Divine Textiles Ltd

Pollibiddut, Shafipur, Gazipur, Dhaka
(24.03977N, 90.25669E)

22 March 2014

Observations

8 storey building typical plan

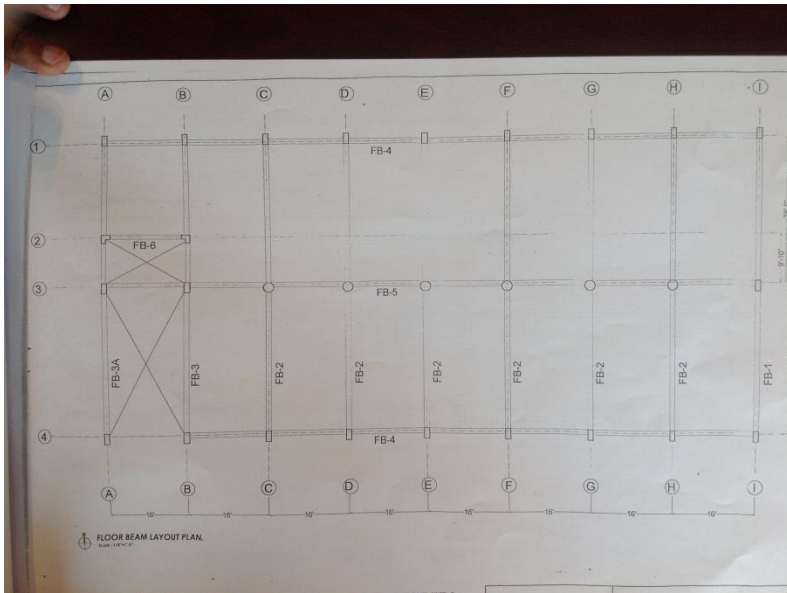
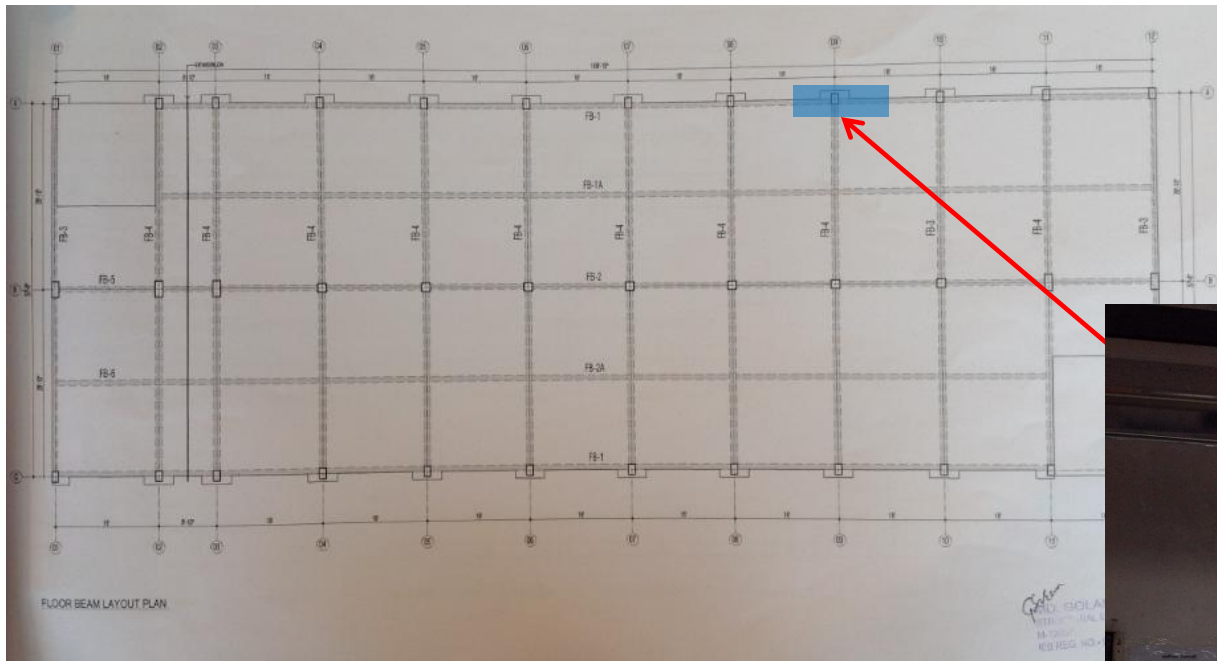
Inconsistencies between structural drawings and the as-constructed arrangement of the factory

Longer grid dimension is 8.9 m (29' 2'') and not 8.53 m (28')

Building Engineer to survey as-built structure and update drawings.

Water ingress on 4th floor of 6 storey building

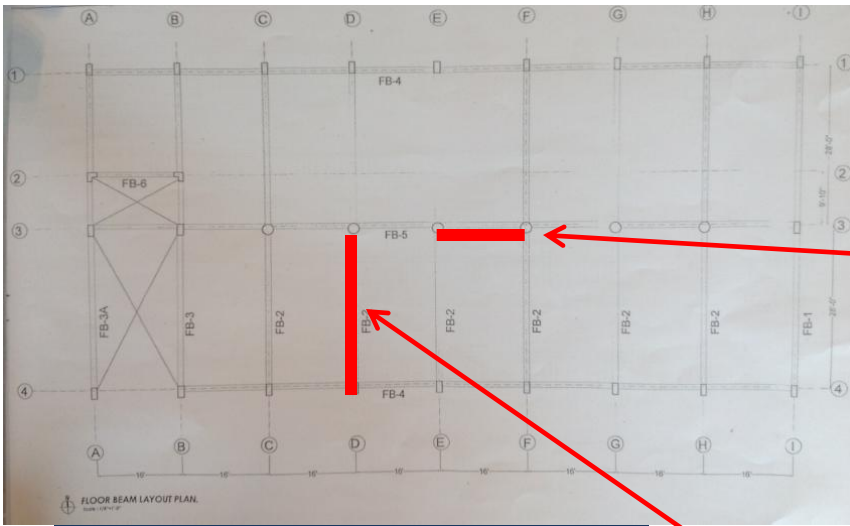
Water ingress through building structure

Water ingress

Areas where water ingress is evident should be investigated and the cause of such should be remedied.
